APPLICANT: Texas Utilities Electric Company
FACILITY: Comanche Peak Steam Electric Station, Units 1 and 2
SUBJECT: SUMMARY OF THE STAFF'S AUDIT OF THE COMANCHE PEAK SAFETY
PARAMETER DISPLAY SYSTEM (SPDS)

SUMMARY OF THE STAFF'S AUDIT
OF THE COMANCHE PEAK SPDS,

June 25 - 26, 1985

THE DATA VALIDATION METHODOLOGY INCLUDES SEVERAL DIFFERENT PROCESSES.

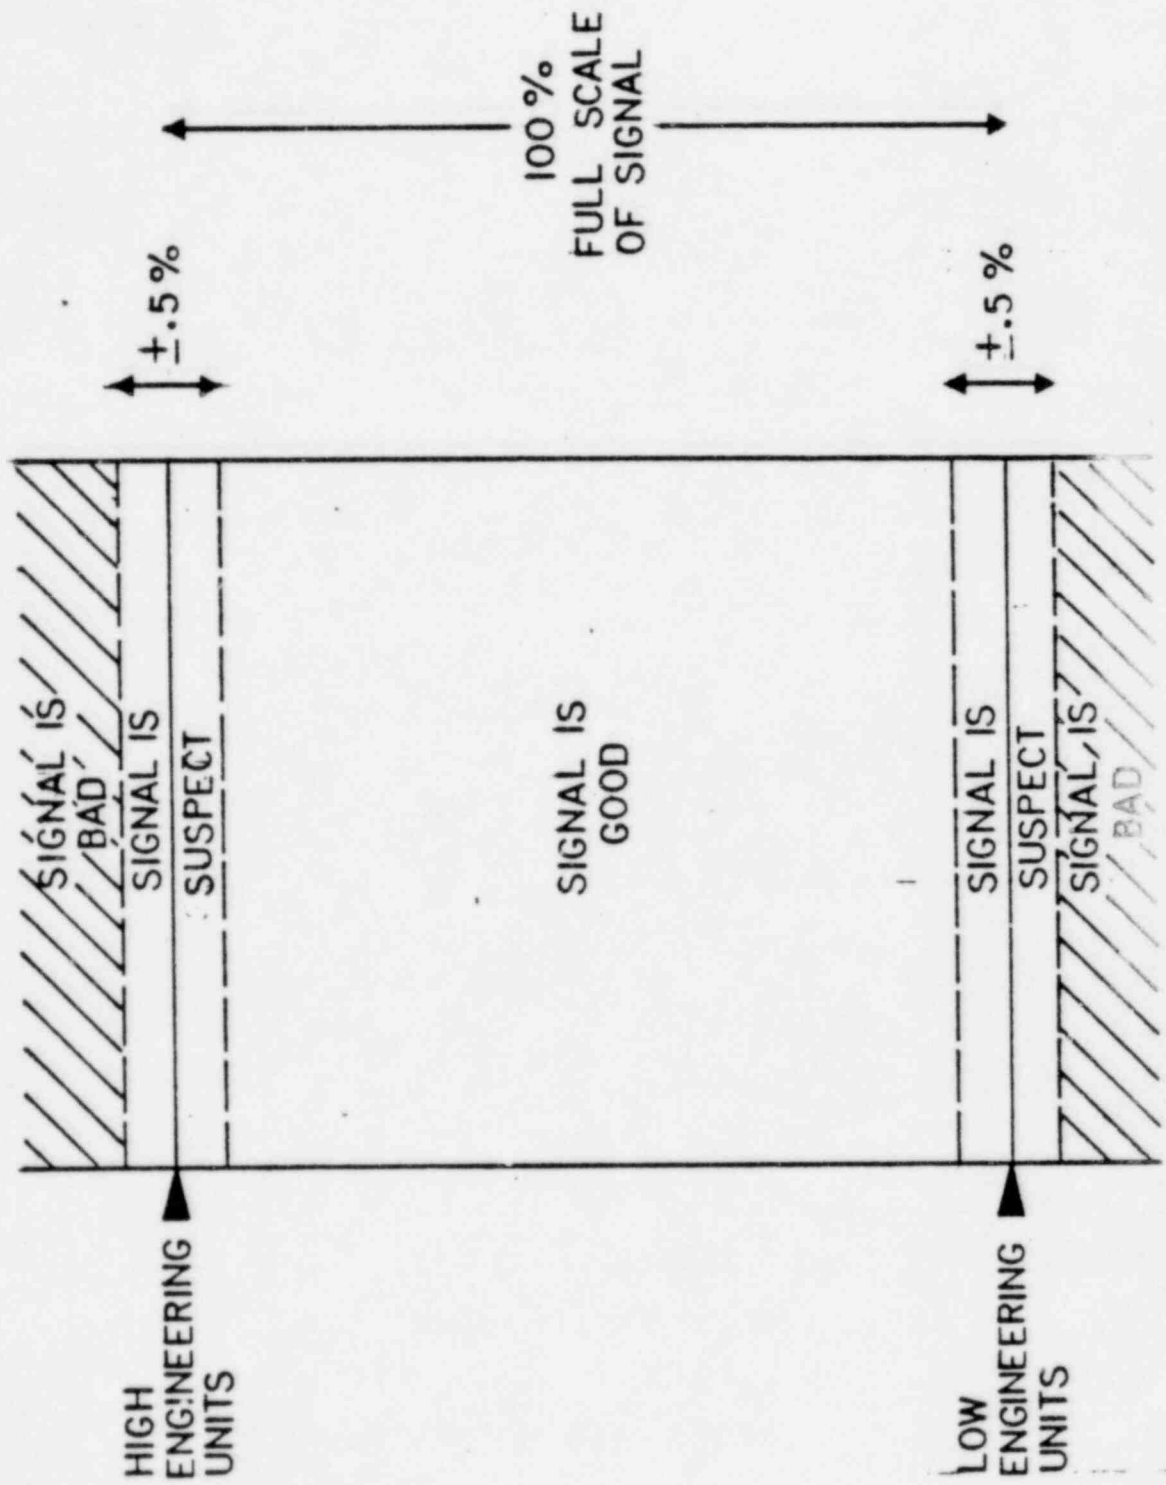
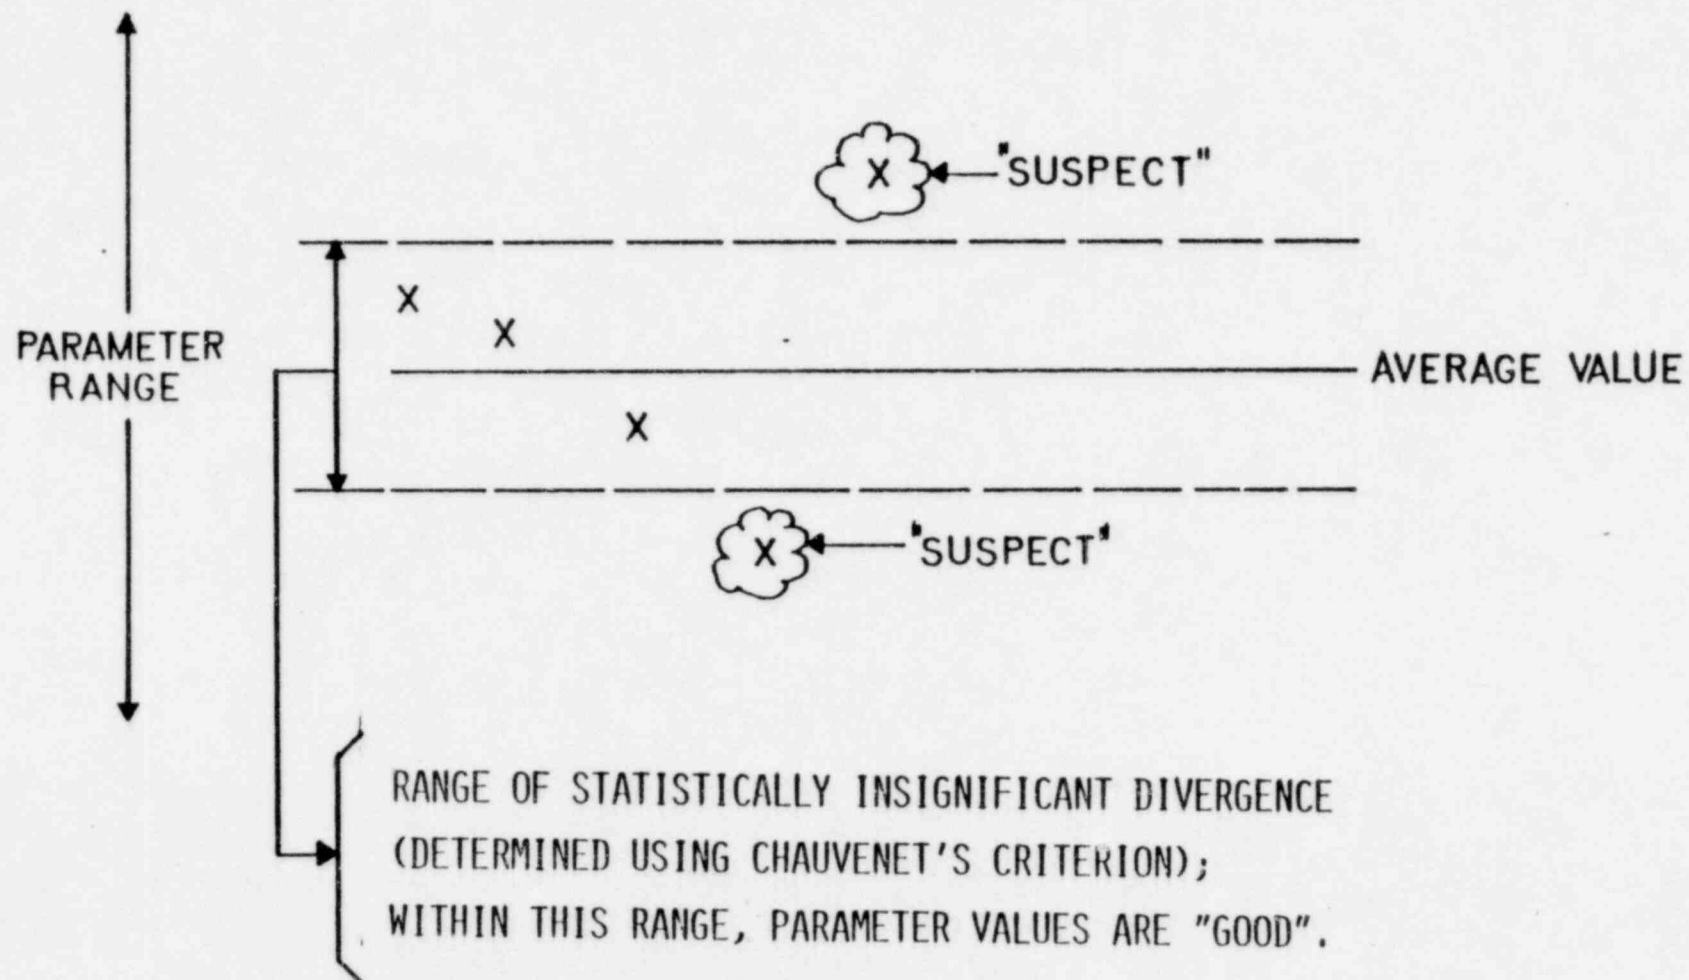
- 4) The data validation methodology for single input parameters is weak and is acceptable only as an interim solution.
- 5) Human factors were considered in the design and the SPDS reflected good human engineering practices except for two items: a) severe glare on the display screen, and b) overprinting of trend graphs, one upon the other, to the point of unreadability.
